Structural Engineering Peer Review

North Sydney Olympic Pool Redevelopment

DA 347/19

North Sydney Council / 28 February 2020

Figure 10 – Existing Wading Pool and Shade Structure, looking across at the children's pool

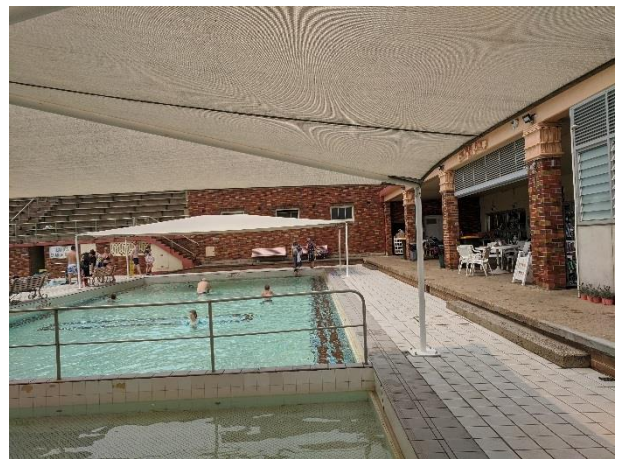
- The shade cloth is in an aged condition and requires cleaning. Shade cloth of this type has a short life, of say a maximum 10 years, before it needs replacing.
- The steel structure supporting the shade cloth is in a deteriorated condition with corrosion visible and paint peeling.
- Floor tiles surrounding the pool are drummy indicating delamination from the concrete substrate below and likely water ingress.

The underlying reinforced concrete structure of these two pools is of similar age to that of the 50m pool, it is therefore likely to be in similar condition. At 84 years of age it is highly likely that the reinforcement is corroding, and the concrete is spalling. As with the 50m pool, it is likely that these pools also leak water.

In our opinion, options for conserving the children's and wading pool structures as they stand are limited because of the age of the structure. The condition of reinforced concrete to these pools will be similar to that of the 50m pool, which concrete testing and investigations have shown to be poor. The modern, basic shade cloth structures above both these pools are also close to the end of their service life.

Figure 14 – Existing Western Staircase Overview

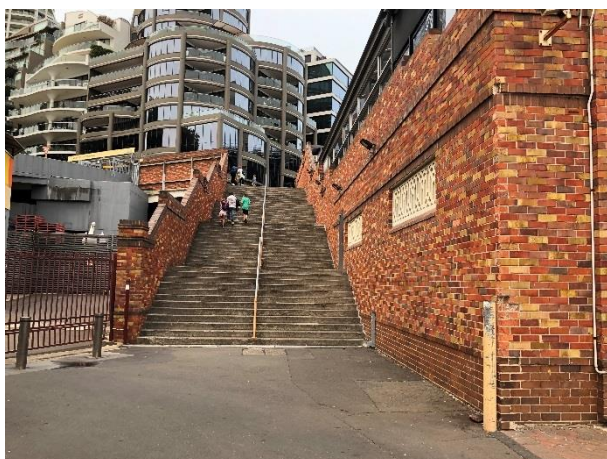
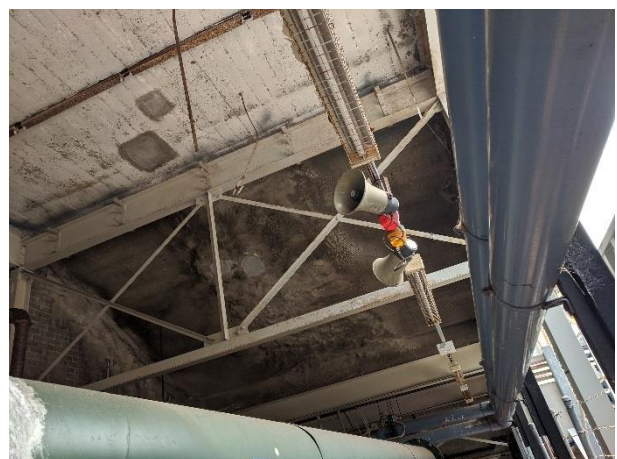
- From below, the concrete landings and treads appear to have undergone significant patch and sprayed concrete repairs over time.
- Supporting structural steelwork is in a corroded condition. Close access to inspect the extent and severity of corrosion and measure sections was not possible at our inspection, however from photographs taken severe corrosion pitting can be seen to some sections, indicating loss of steel section and strength.
- The Brickwork wall along the north-west side of the staircase, facing Luna Park has steel post and rail stiffeners behind it, strengthening the brickwork⁷. The strength and integrity of this wall is unknown.

The steelwork supporting the western staircase is corroded and the suspended concrete landings and flights have been extensively repaired previously. In our opinion, options for conserving and reusing the staircase are limited because of its poor condition. Also, it would not be effective and waterproof as a roof to enclose the proposed gym and plantroom extensions.

Figure 16 – Existing Plantroom Overview

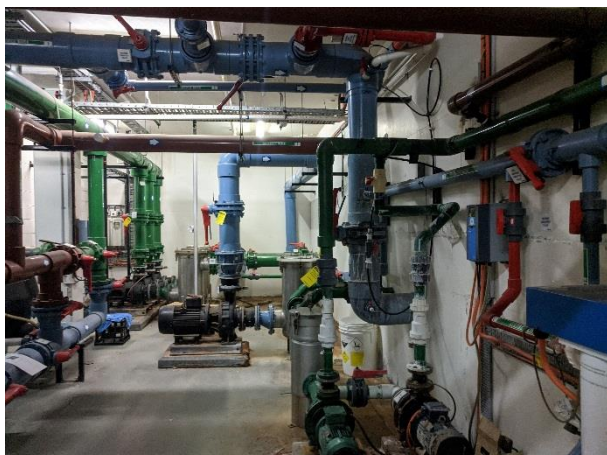
- Efflorescent staining is prevalent to concrete sections
- Paint is delaminating from masonry wall sections
- Cracking through rendered brickwork is extensive below the western staircase exit at Level 1.

It is reasonable that redevelopment of the pool complex to the extent proposed will require new and extended plantrooms. The walls marked for demolition are back-of-house and in poor condition. The north-western wall is badly cracked around the door leading to the external area beneath the western staircase. This wall requires reconstruction, to support the reconstructed stair. In our opinion, there is limited scope to conserve these elements of the building.

Figure 21 – Concrete path surrounding sun deck at different level to pool

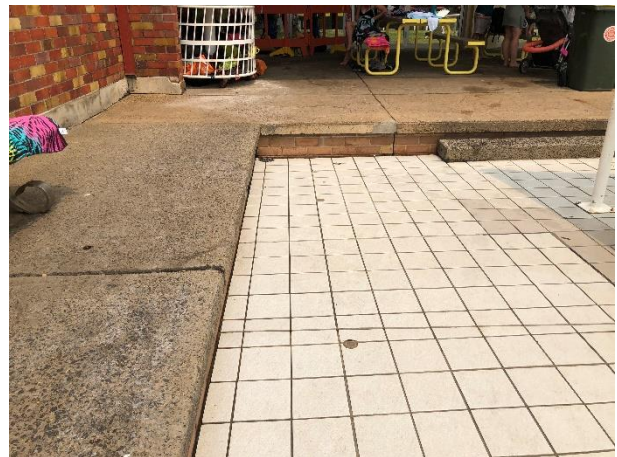
- Brick faces to several columns were deteriorating due to hard cementitious mortar having been used for repointing.
- Cracks were noted to concrete edge beams, suggesting the onset of reinforcement corrosion.
- Several cracks were noted to the sun deck masonry parapets, to the east and north.
- Plant growth was evident within bed joints around header courses in the masonry parapets.
- The existing brick parapets may require strengthening for earthquake actions.
- The aluminium door, window and louver frames are tired-looking and unattractive.
- The Ripples Café enclosure uses fibre cement which is dilapidated and unattractive.
- The colonnade beneath the sun deck (intended for children's pool and family use) has a concrete path around it at a higher level than the pool surround and not in keeping with the pool surround. The single step is a potential trip hazard for pool users.
